Access Compliance Report

Public Rights-of-Way

Intersection ID: N/A	Main Street: E STONEWALL ST	Cross Street: S DAVIDSON ST	Location: N
ADA ID: 5EBDDCE1BF2D	Ramp Type: Para	Initial Pass/Fail: Fail	Overall Compliance: No
Codes/Mitigation Info/Possible Solution		Field Measurements/Component Compliance	
Severity Score: 13.75

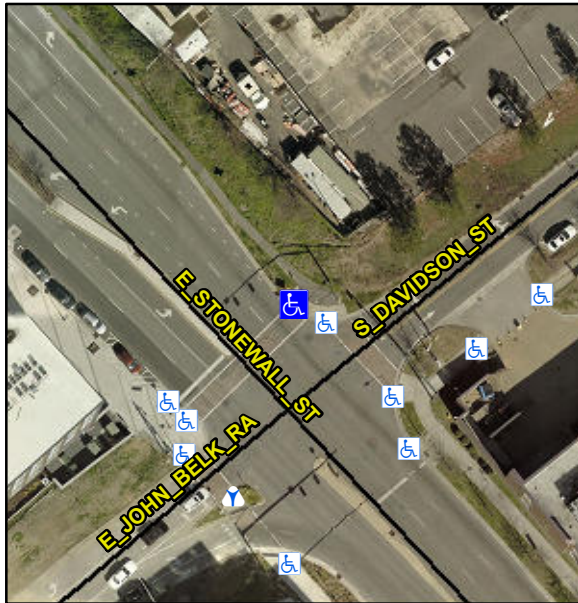
R304.3.2, R304.5.3

Compliance	Description	Data	Compliance	Description	Data
N/A	Ramp Length LT (in)	62.0	N/A	Ramp Length RT (in)	54.0
Yes	Ramp Width LT (in)	72.0	Yes	Ramp Width RT (in)	72.0
No	Ramp Slope LT (%)	9.6	Yes	Ramp Slope RT (%)	5.6
Yes	Ramp XSlope LT (%)	1.7	No	Ramp XSlope RT (%)	2.6
N/A	Landing Length (in)	N/A	N/A	DWS Provided?	N/A
N/A	Landing Width (in)	N/A	N/A	DWS Contrast?	N/A
N/A	Landing Slope (%)	N/A	N/A	DWS Length (in)	N/A
N/A	Landing X Slope (%)	N/A	N/A	DWS Full Width?	N/A
N/A	Landing Curb? (Y/N)	N/A	N/A	DWS Offset (in)	N/A
N/A	Shared Landing?	N/A			
N/A	Gutter Ponding?	N/A	N/A	Gutter Slope (%)	N/A
N/A	Gutter Lip Ht (in)	N/A	N/A	Gutter X Slope (%)	N/A
N/A	Painted X Walk1?	Yes	N/A	Painted X Walk2?	N/A
	X Walk 1 Direction	To SW		X Walk 2 Direction	N/A
N/A	X Walk 1 Width (in)	126.0	N/A	X Walk 2 Width (in)	N/A
	X Walk 1 Slope (%)	3.7		X Walk 2 Slope (%)	N/A
	X Walk 1 X Slope (%)	0.4		X Walk 2 X Slope (%)	N/A
N/A	Ramp inside XWalk1?	Yes	N/A	Ramp inside XWalk2?	N/A

Remove & Replace Entire Ramp.
